SCIENTIFIC NOTEBOOK 687E

STRUCTURAL AND GEOPHYSICAL ANALYSIS OF THE DOE NYE COUNTY CROSS SECTIONS, YUCCA MOUNTAIN, NEVADA

Project: This notebook document procedures, codes, data, and results used in support of conclusions reached for the review of DOE response to USFIC.5.05 and RT.2.09 AIN-1 (Ziegler, 2002) and Intermediate Milestone: _____. This notebook documents independent staff analysis of geophysical data used in the construction of the Nye County cross sections (Spengler and Dickerson, 2003), as well as independent structural analysis and restoration.

Figure 3. Gravity-derived cross sections for Nye-1 (a), Nye-2 (b) and Nye-3 (c). Note that the cross sections capture the overall basin morphology found in the original DOE Nye County cross sections. Only structural features with greater than 100m of vertical offset were identified.

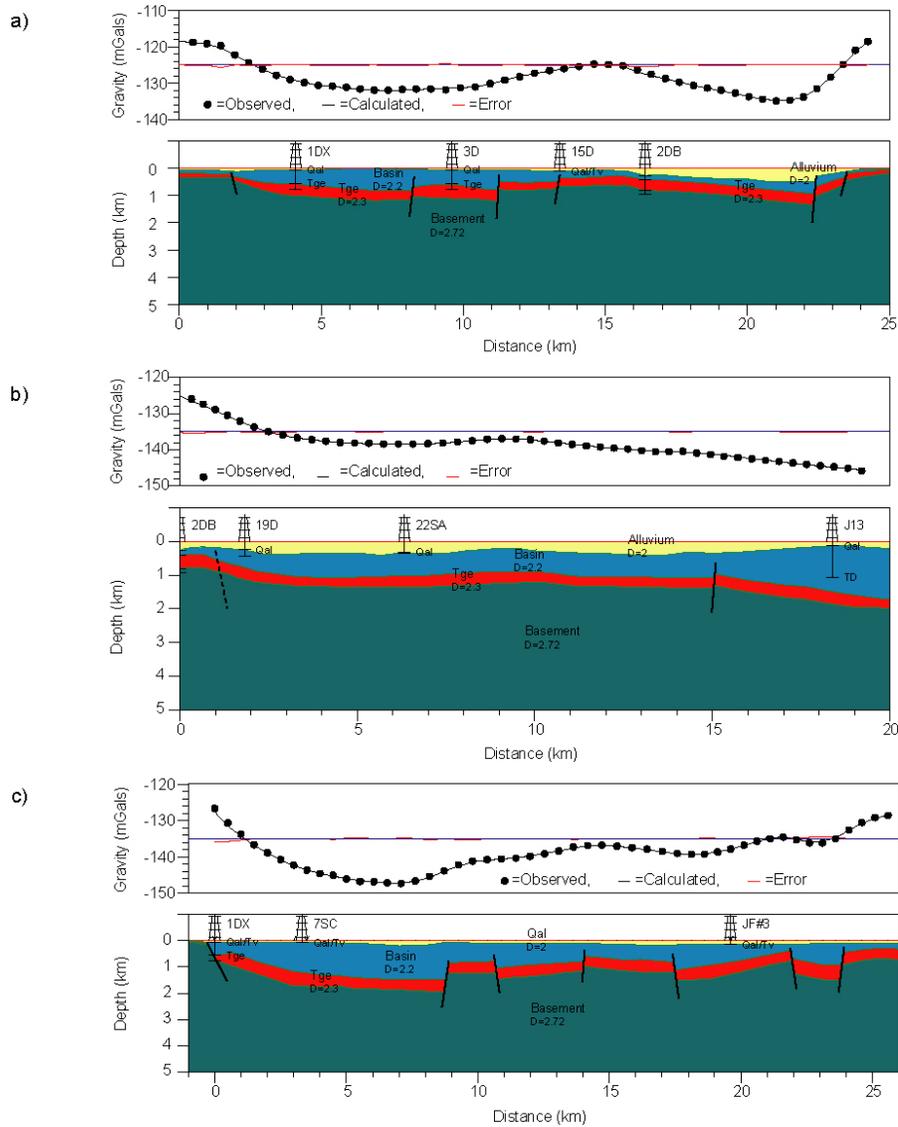
Our gravity analysis reveals that simplified cross sections, with significantly fewer faults, can explain observed gravity anomalies. Because the gravity models are dependent on the unit gravity values, we identified the first-order controls influencing the overall shape of the anomaly and basin morphology. Density contrasts between the units, specifically between the basal Tertiary gravel unit and the Paleozoic basement, are a primary influence on the gravity anomaly. We determined that an increase in the gravity value of 0.1 g/cm³ for the basal Tertiary units or a decrease of 0.1 g/cm³ of the Paleozoic basement resulted in a 250 m increase in basin depth. Therefore, a 5% uncertainty in the density value of the units could greatly influence the subsurface stratigraphic interpretation.

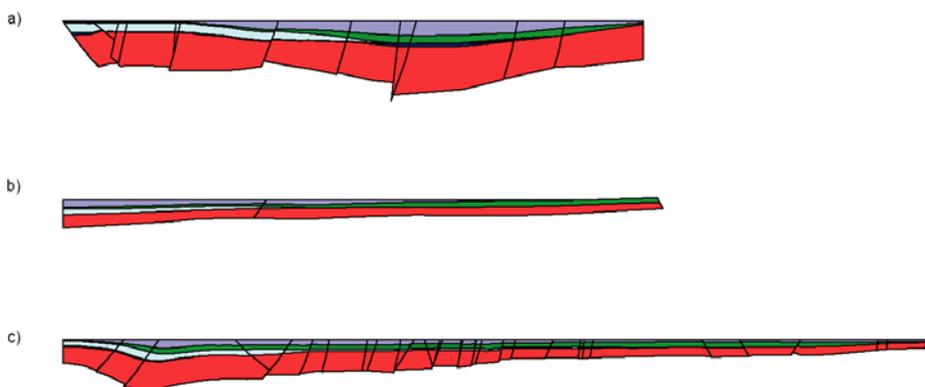
Successive restoration of stratigraphic units also revealed little to no growth along high-angle normal faults and major block bounding faults. Instead, most faults were active at constant rates after the deposition of the topmost volcanic tuff unit. Preliminary calculations and observations indicate that the majority of faults were active after the deposition of the Paintbrush Group (~12.7 MA) for an undeterminable amount of time. However, because the majority of faults do not displace the Quaternary alluvium in the DOE interpretation, faulting ceased prior to 2MA. Furthermore, the restoration revealed minor errors including abrupt changes in thickness of the basal Tertiary gravel unit and rotation along planar faults. However, the absence of major errors and structural inconsistencies indicates that the DOE cross sections are one of many possible stratigraphic and structural interpretations.

Figure 4. Restoration of the Nye County cross sections to unit Tcds. The restoration of Nye-1 (a) is west of the Highway-95 fault. Nye-2 (b) and Nye-3 (c) are restored entirely for this unit. The only identifiable problem with this restoration is the abrupt changes in the thickness of Tge in Nye-1 and Nye-3. Furthermore, there is little to no growth along faults indicating the faults were cut after the deposition of the topmost tuff unit.
